PITT-01-20-060

**Re: Sunoco Pipeline L.P. – Pennsylvania Pipeline Project (Mariner East II)  
Chapter 102 Permit No. ESG0100015001 Major Modification – HDD 0620  
Middletown Township, Delaware County, PA**

On behalf of Sunoco Pipeline L.P. (SPLP), please accept this letter and enclosed drawings and information as a response to Technical Deficiency Comments, dated January 9, 2020, from the Pennsylvania Department of Environmental Protection (Department) for a major modification to the above-referenced Chapter 102 permit.

DATE:	2/6/17
PROJECT NO.:	112C05958
DESIGNED BY:	JB
DRAWN BY:	BH
CHECKED BY:	RS
COPYRIGHT TETRA TECH INC.	
<b>ES-6.18</b>	
SHEET 6.18 OF 60

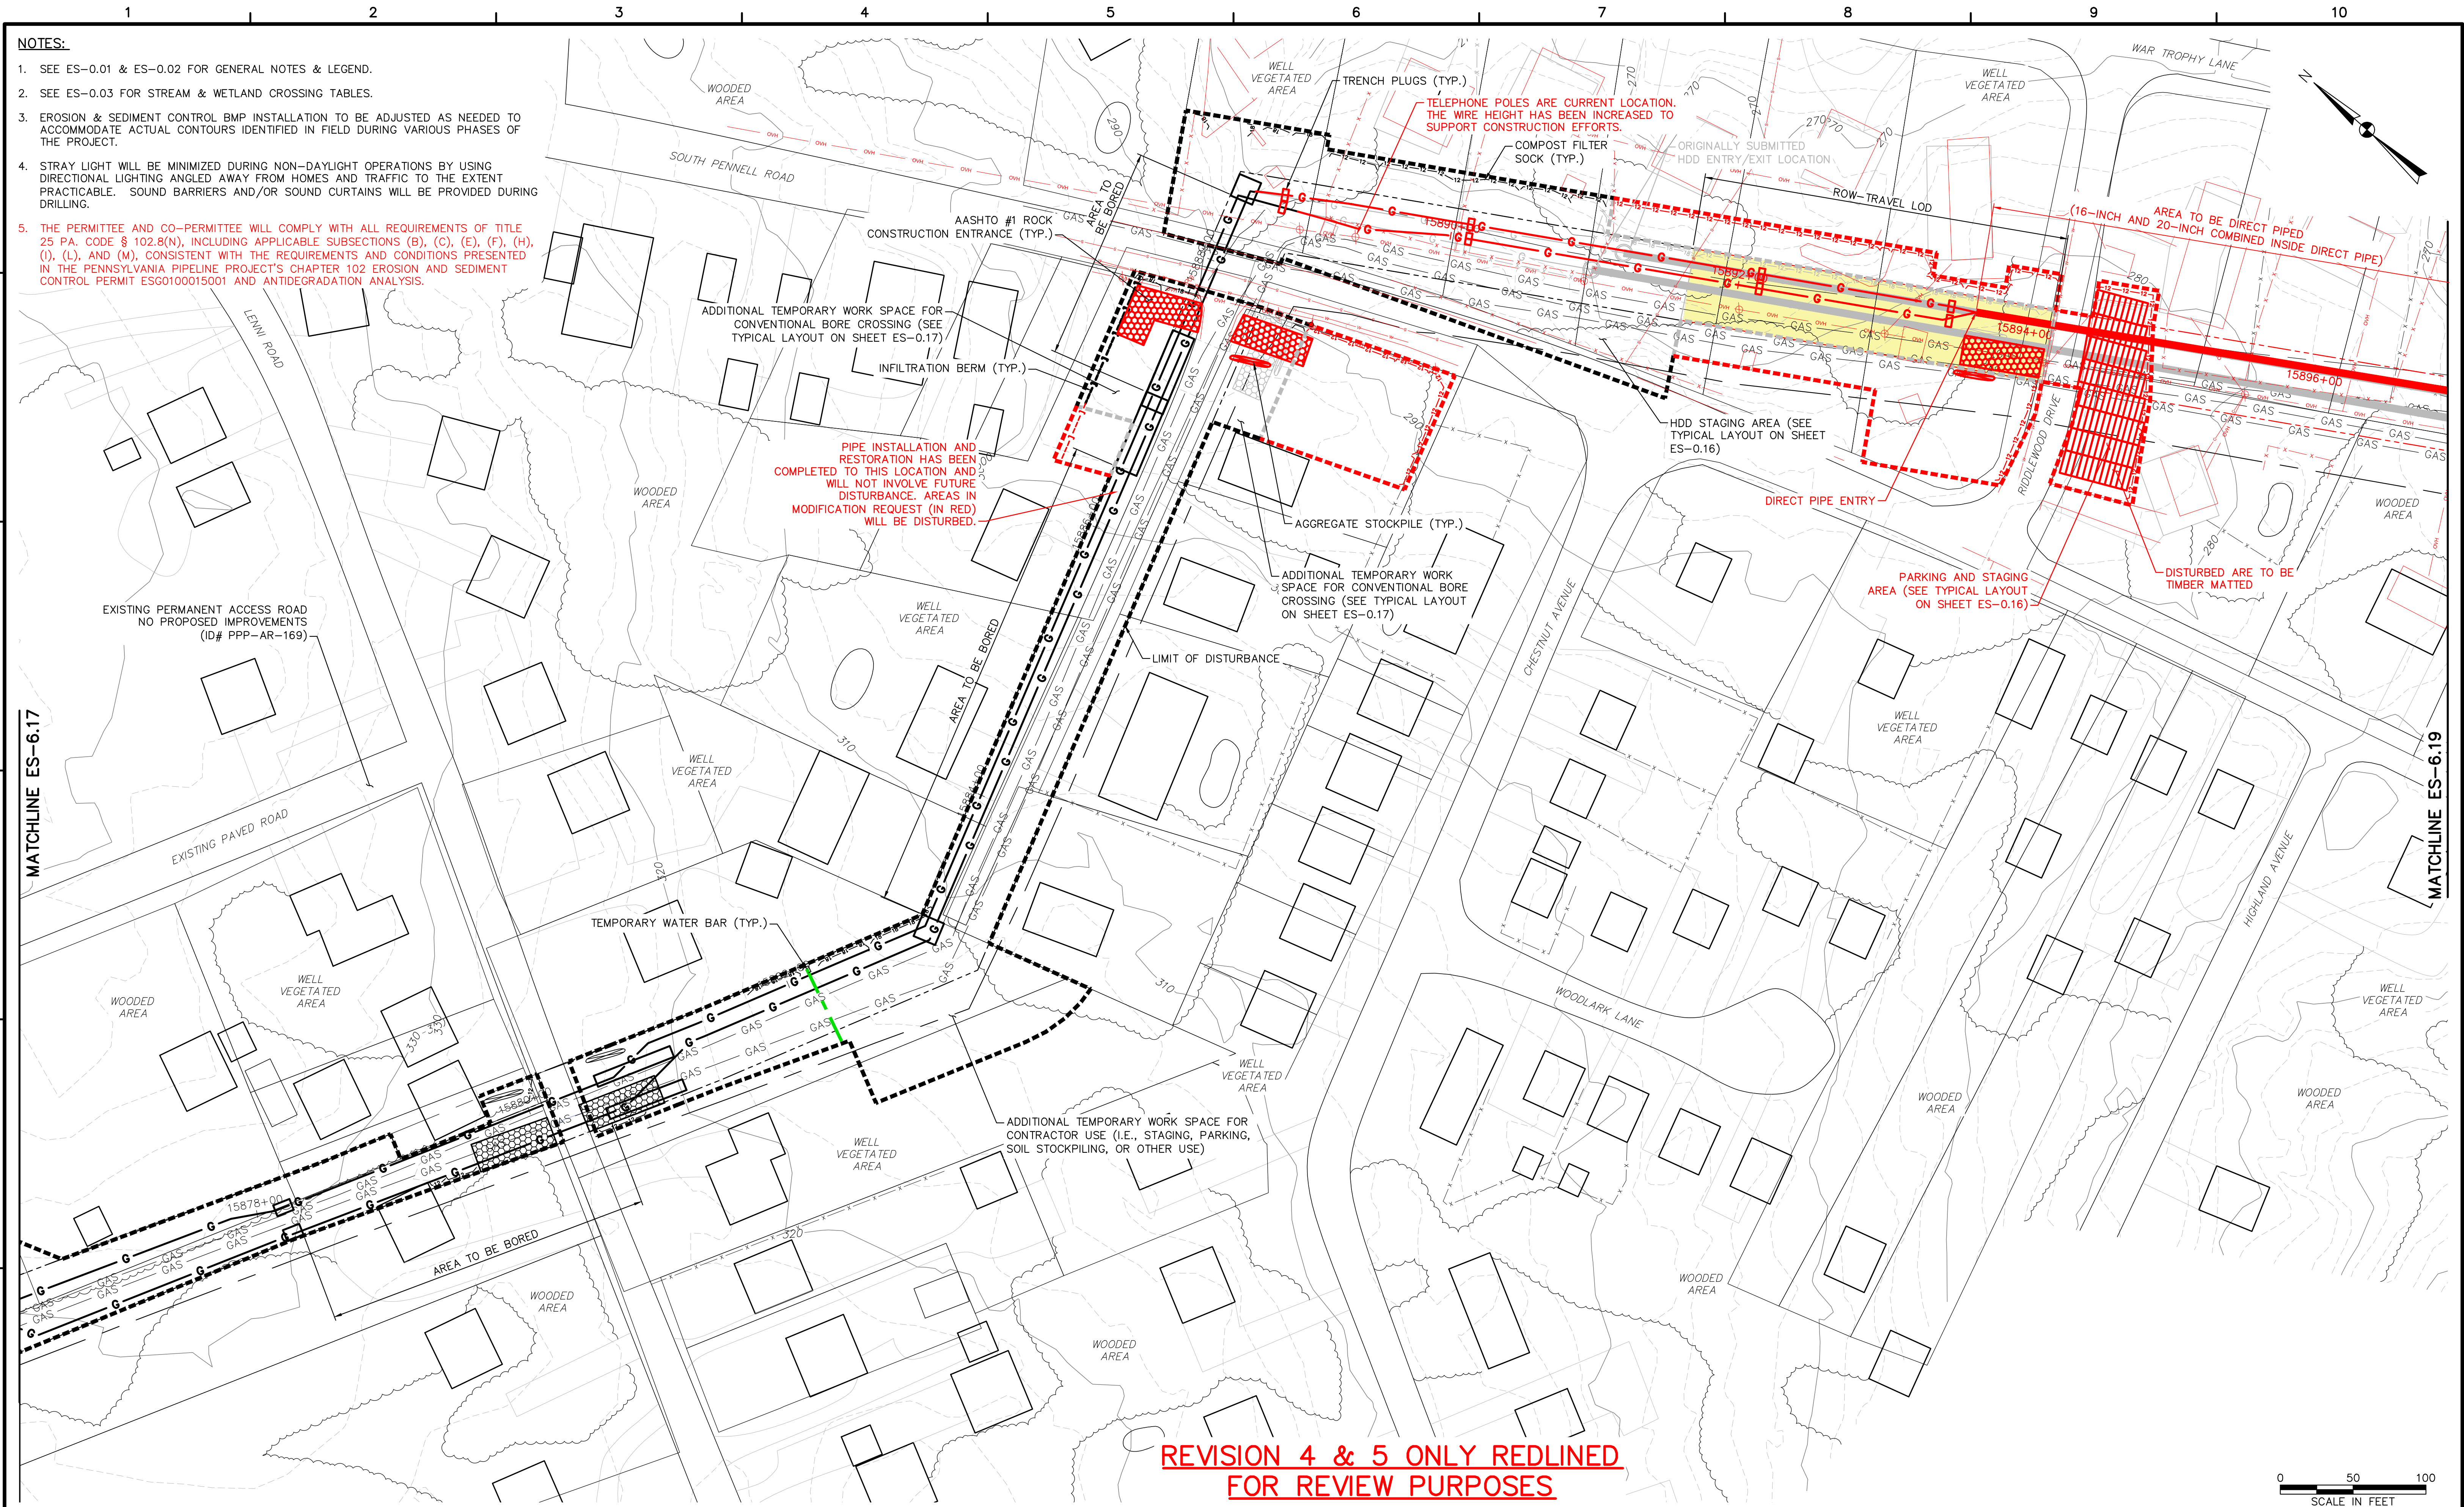
2. **Comment:** Plans should label work that has been completed and will not involve future disturbance. Chapter 102.11(a)(1)

3. **Comment:** Unclear what the term "direct pipe" used on sheet ES-6.18 and 6.19 refers to? Chapter 102.11(a)(1)

**Response:** *A flag has been added to ES-6.18 at approximate station 15886+00 to identify pipe installation and restoration has been completed to this location and will not involve future disturbance. Area in this modification request identified in red will have earth disturbance activities conducted. The 16-inch bore by the existing block valve on ES-6.20 is identified as installed. Additional activities for installation of the 20-inch pipeline are planned in this area, but the 16-inch pipe in this area has been installed.*

**Response:** *The "direct pipe" method of pipeline installation is also known as "microtunneling". This method of pipeline installation is a remote-controlled, continuously supported pipe jacking method. During the direct pipe installation, operations are managed by an operator in an above ground control room alongside of the installation pit. Rock and soil cutting and removal occurs*

**Response:** *Yes, the grayed-out lines shown being deleted. The two pipelines will be installed in a single casing/pipe. The call out for the Direct Pipes on ES-6.18 and ES-6.19 have been updated to call out both the 16-inch and 20-inch pipelines inside of the Direct Pipes.*
